APPLICATION FOR PERMISSION UNDER SECTION 16 OF THE TOWN PLANNING ORDINANCE (CAP. 131)

| For Official Use Only 請勿填寫此欄 | Application No. 申請編號 | A/NE-MUP/214 |

**Proposed Temporary Warehouse with Ancillary Facilities for a
Period of 3 Years and Associated Filling of Land in "Agriculture" and
"Residential (Group D)" Zones, Lots 107 (Part), 109 (Part), 115 (Part), 116 (Part),
117, 118, 119, 120, 121, 122, 123, 124 S.A, 124 S.B, 125, 126 (Part), 127 (Part),
128 (Part), 131, 133 (Part), 134, 135 (Part), 136, 141, 142, 143, 144 RP (Part),
148, 150, 151 and 152 in D.D. 38 and adjoining Government Land, Sha Tau Kok
(Compliance with Approval Condition (c) for Planning Application No. A/NE-MUP/185)**

(S.16 Planning Application No. A/NE-MUP/214)

DRAWING NUMBER
FIGURE 3.2

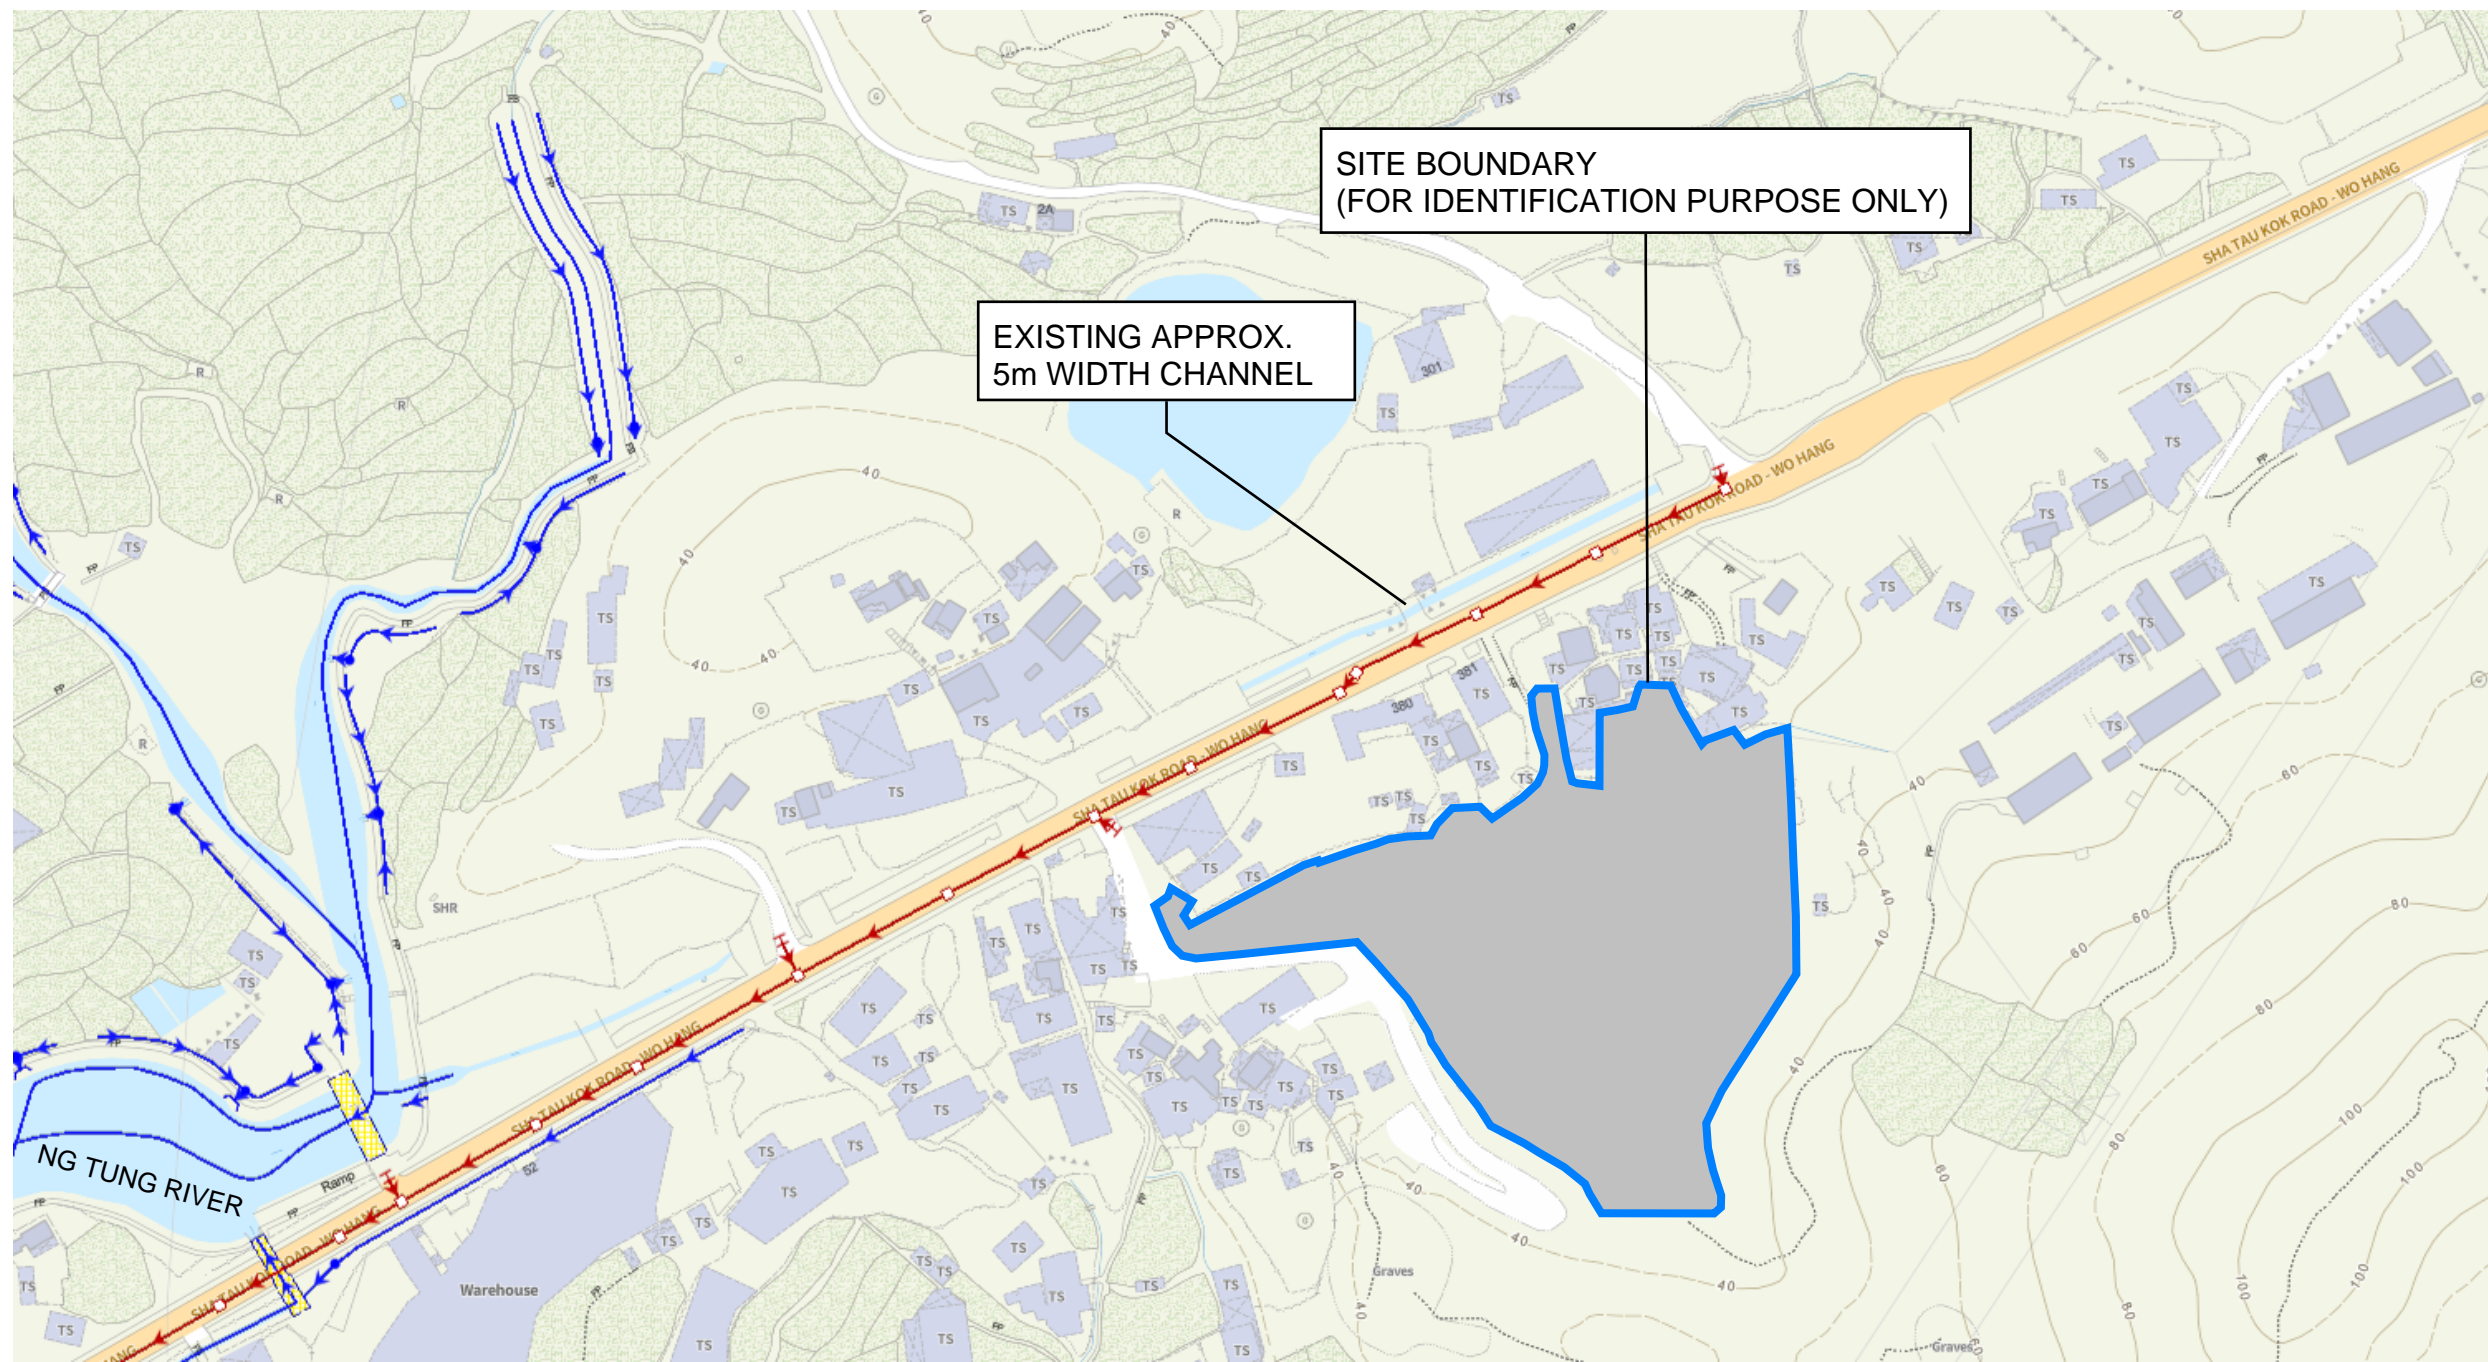
| Comments of the CE/MN, DSD (Contact Person: Mr. Wilson TAI; Tel: 2300 1693) | | |
|--|--|--|
| (2) | It is noted from section 1-1 in Appendix D that the formation level of some portions of the application site are higher than the adjacent existing ground level. Hence, the cover level of the proposed u-channel at those portions should be revised to match the existing ground levels so as to ensure no adverse drainage impact to lands and premises adjoining the development site. | Noted. The cover level of proposed channel should be made with existing ground level on site. Please refer to updated Appendix A, Appendix D and Figure 3.2 (Appendix II). |
